Supplemental Environmental Impact Statement for the International Boundary and Water Commission South Bay International Wastewater Treatment Plant Long Term Treatment Options

**Final Supplemental Environmental Impact Statement
for the
International Boundary and Water Commission
South Bay International Wastewater Treatment Plant
Long Term Treatment Options
March 1999**

Chapter 3.0 Modifications/Updates to the DSEIS

Figure 2.1-3
Oceanographic
Features
 SEIS for SBIWTP Long-Term Treatment Options

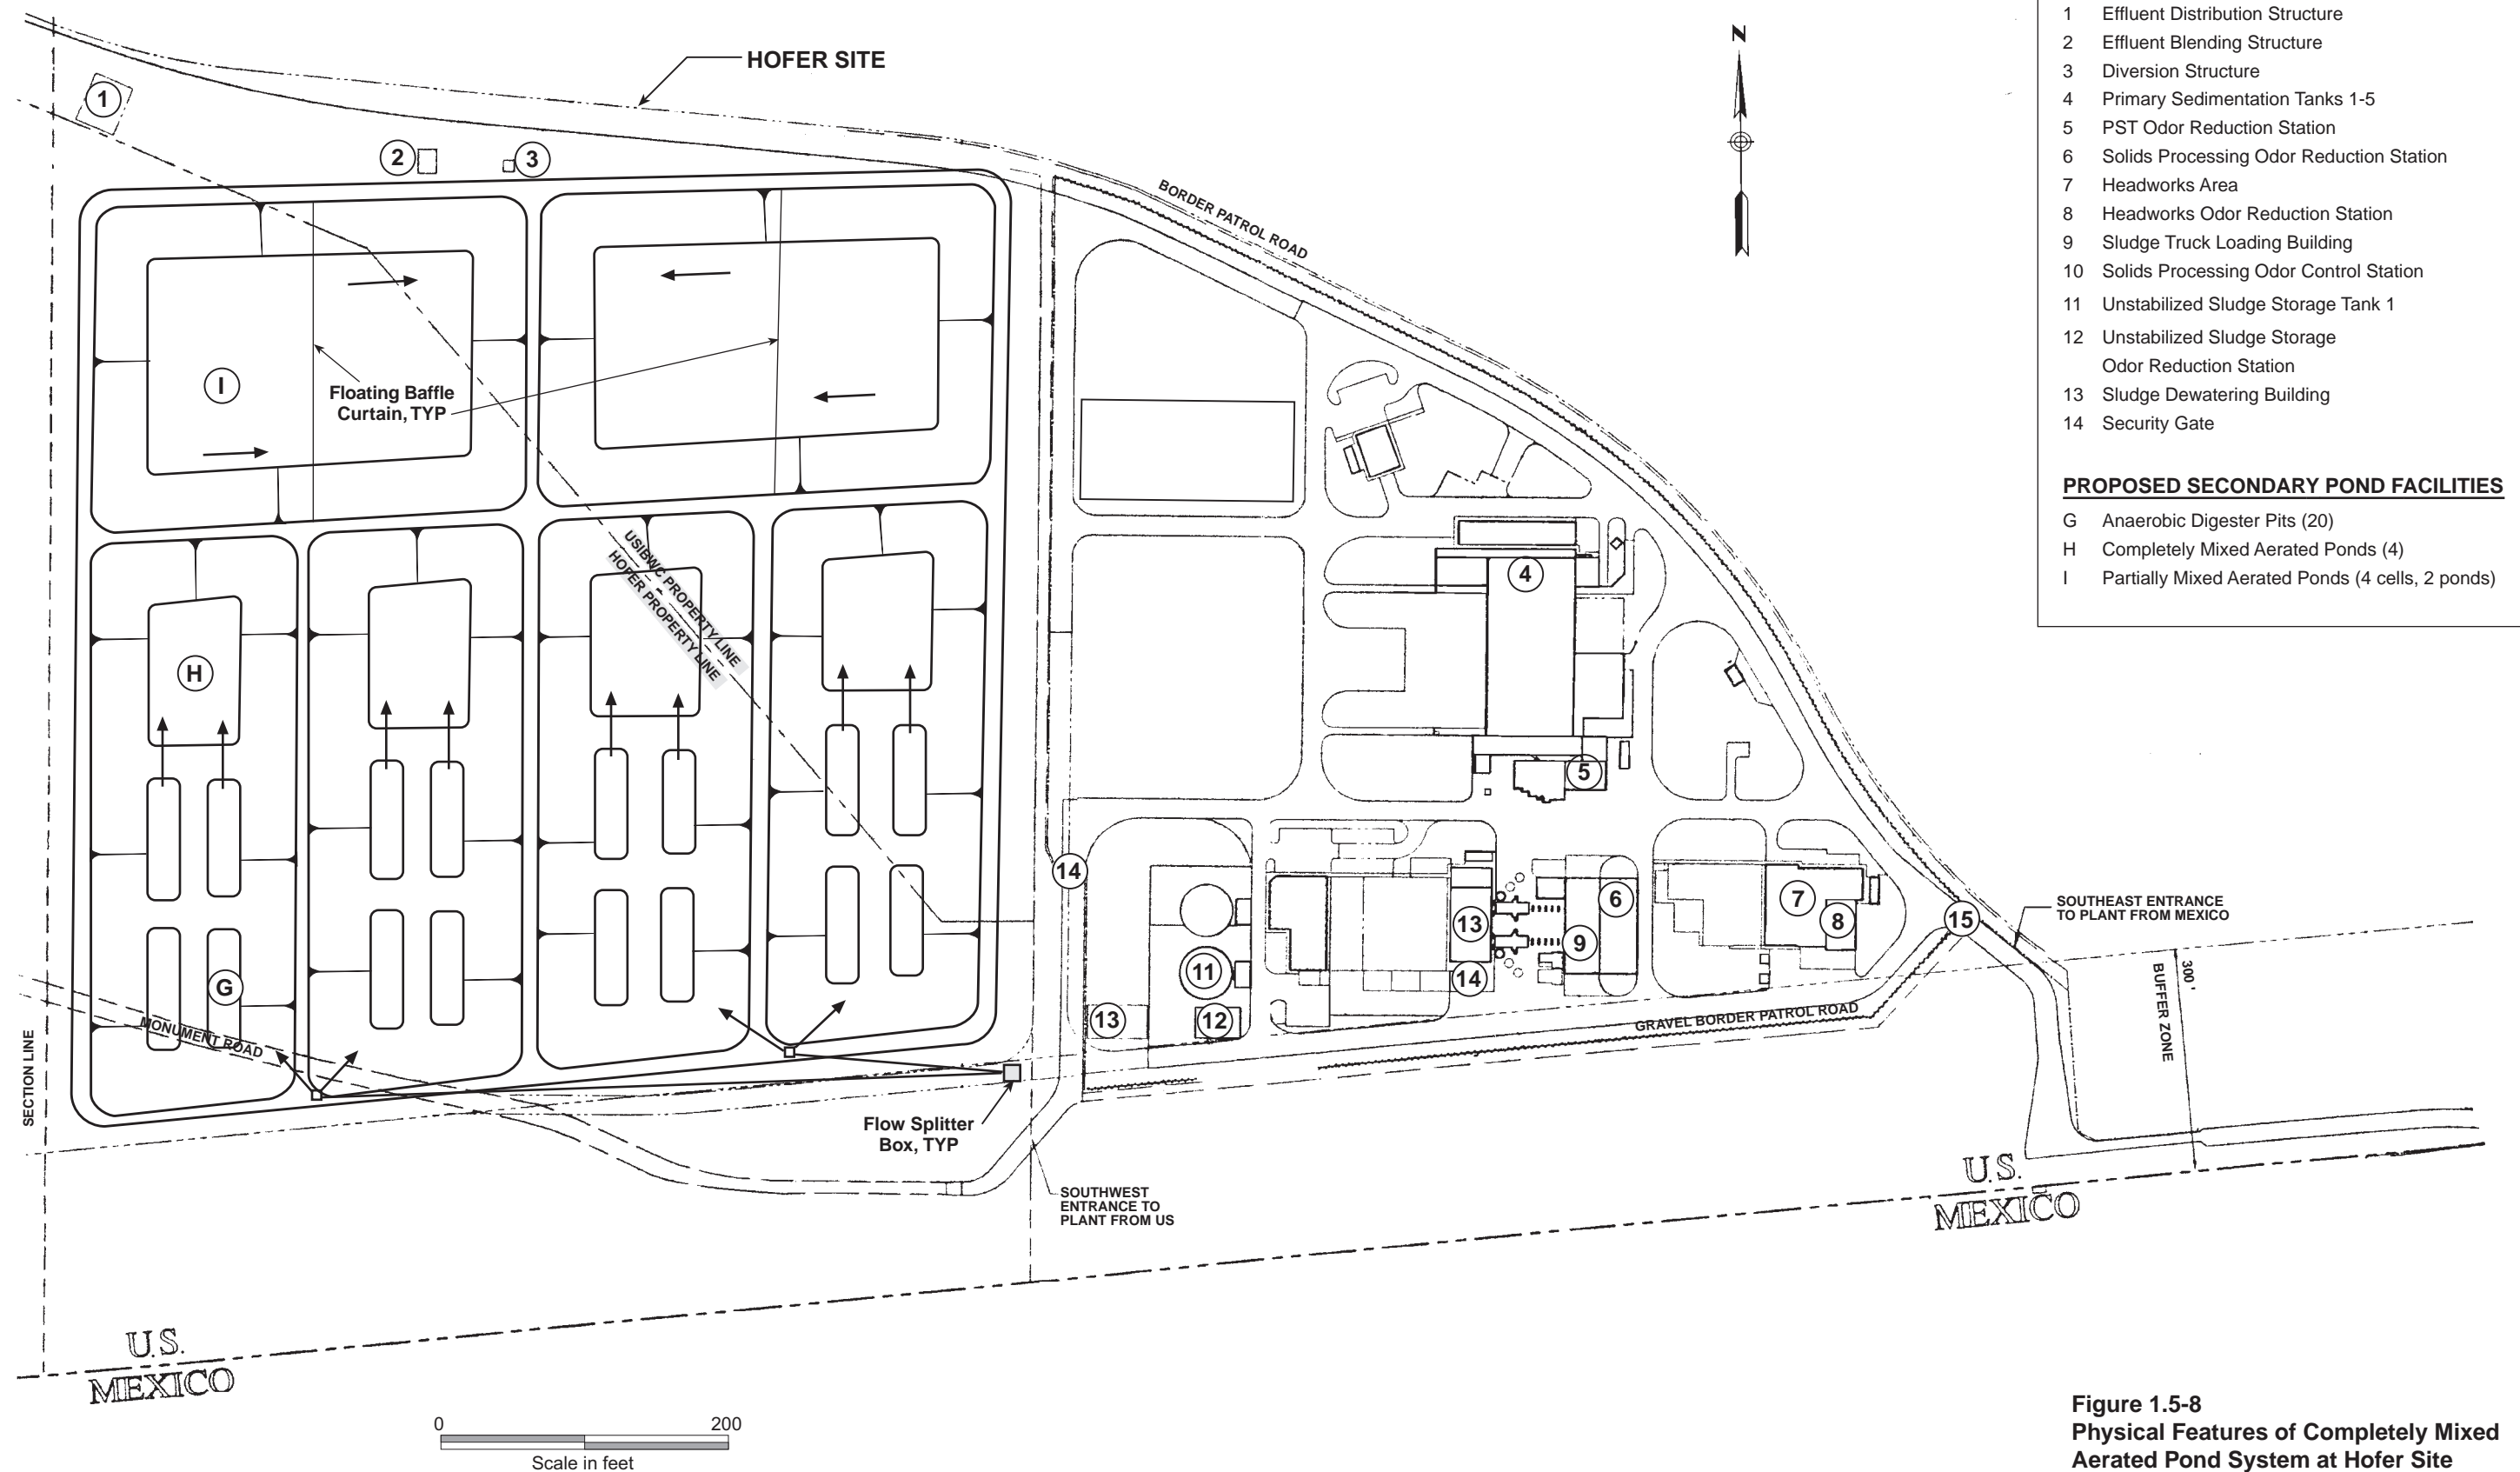
Figure 2.1-3 in Section 2.1.4.1 of the DSEIS is revised to show an added artificial reef. The coordinates of the added reef are: 32° 32' 38" North, 117° 14' 48" West. The revised figure is included at the end of this chapter.

3.2.3 Changes to Figure 1.5-8, Physical Features of Completely Mixed Aerated Pond System at Hofer Site Alternative

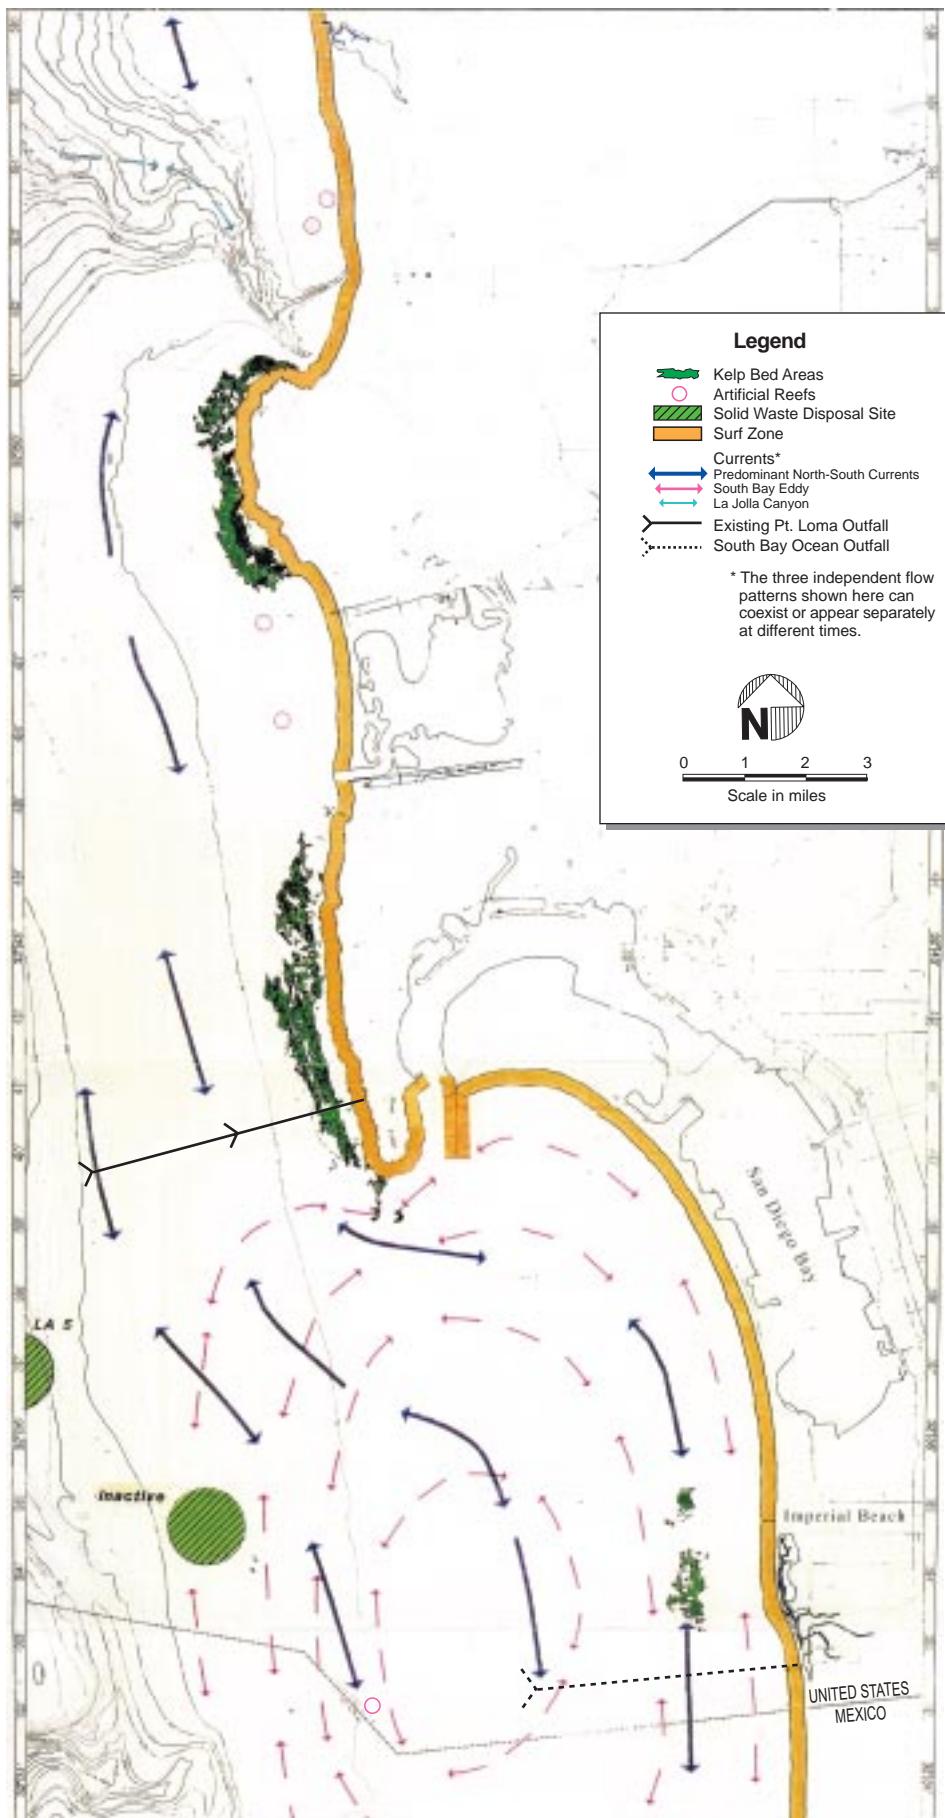
Figure 1.5-8 in Section 1.5.3.1 of the DSEIS is revised to clarify the Hofer/USIBWC property line. The revised figure is included at the end of this chapter.
